# UNITED STATES PATENT AND TRADEMARK OFFICE

APPLICATION NO.	FILING DATE	FIRST NAMED INVENTOR	ATTORNEY DOCKET NO.	CONFIRMATION NO.
10/511,429	10/15/2004	Edward Torrance	501-22	2401
23117 7590 01/03/2007 NIXON & VANDERHYE, PC 901 NORTH GLEBE ROAD, 11TH FLOOR ARLINGTON, VA 22203			EXAMINER TRAN, HANH VAN	
			ART UNIT 3637	PAPER NUMBER
SHORTENED STATUTORY PERIOD OF RESPONSE			MAIL DATE	DELIVERY MODE
3 MONTHS			01/03/2007	PAPER

<b>Office Action Summary</b>	<b>Application No.</b> 10/511,429	<b>Applicant(s)</b> TORRANCE, EDWARD	
	<b>Examiner</b> Hanh V. Tran	<b>Art Unit</b> 3637

1. This is the Final Office Action from the examiner in charge of this application in response to applicant's amendment dated 10/5/2006.

**FIG. 5**

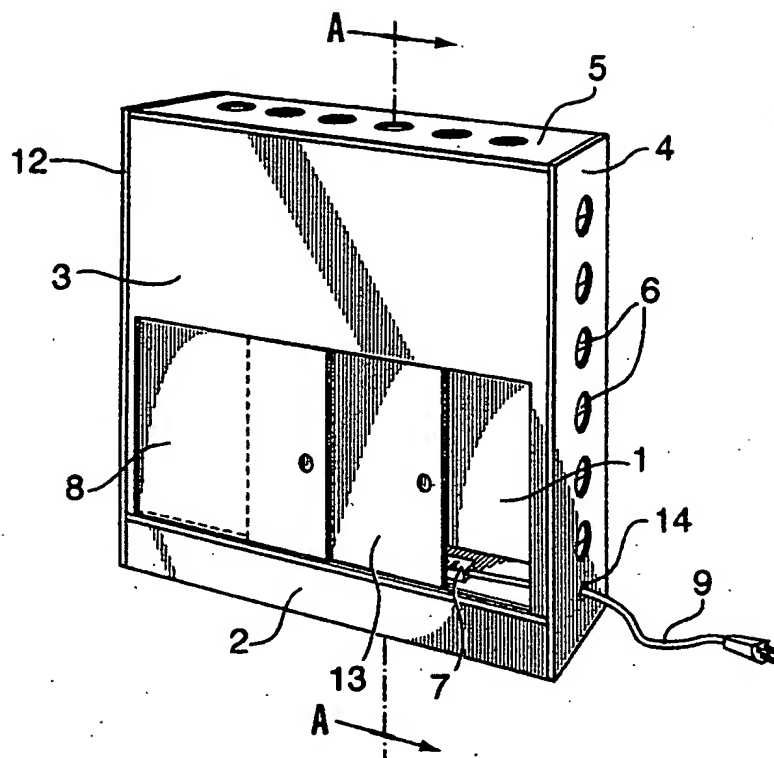
2. The drawings are objected to under 37 CFR 1.83(a). The drawings must show every feature of the invention specified in the claims. Therefore, the limitation in claims 1 and 10 of each closure means having "a fixed portion and a selectively rotatable portion" must be shown or the feature(s) canceled from the claim(s). No new matter should be entered.
